Project: WSSDA Headquarters  
Concept Design Review: September 13, 2018  
Detail Design Review: November 15, 2018  
Prepared By: Catherine McCoy, Associate Planner

Master File: # 18-2958

**CITY OF OLYMPIA**  
**BASIC COMMERCIAL DESIGN CRITERIA**  
**Chapter 18.110**

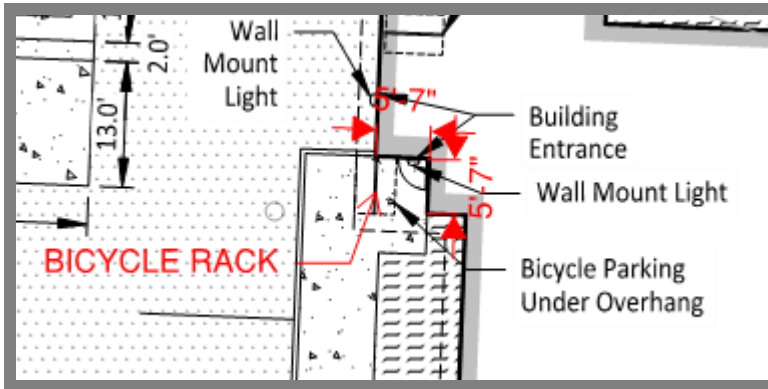
Two long-term and two short-term bicycle parking spaces are required for the 8,975 sq.ft. building. At this stage of design review a Bicycle Parking Plan is shown on Sheet A1.10, New Site Plan, although the single inverted U-style bike rack is less than 15 inches from a (northwest) building entrance. Bicycle parking should be convenient and provide security and weather protection. At least five feet of maneuvering space should be provided around each bike rack.

- Address the suitability of the short-term bicycle parking location - the proximity to the building doorway and the lack of space available for maneuverability.
- Add seating near the main entrance to the building.

Two benches have been added near the main building entrance (Attachment 4). Based on Board input at the Concept Design Review Board meeting, the bicycle rack has been rotated 90° to allow a little more space for bike parking and building access, however there continues to be limited maneuvering space at the building entrance for either. There should be at least 5 feet maneuvering room, or clear space, around each bicycle rack (OMC 18.38.220).

- Relocate the short-term bicycle parking, or redesign the space to accommodate a cyclist comfortably without impeding access of site users.
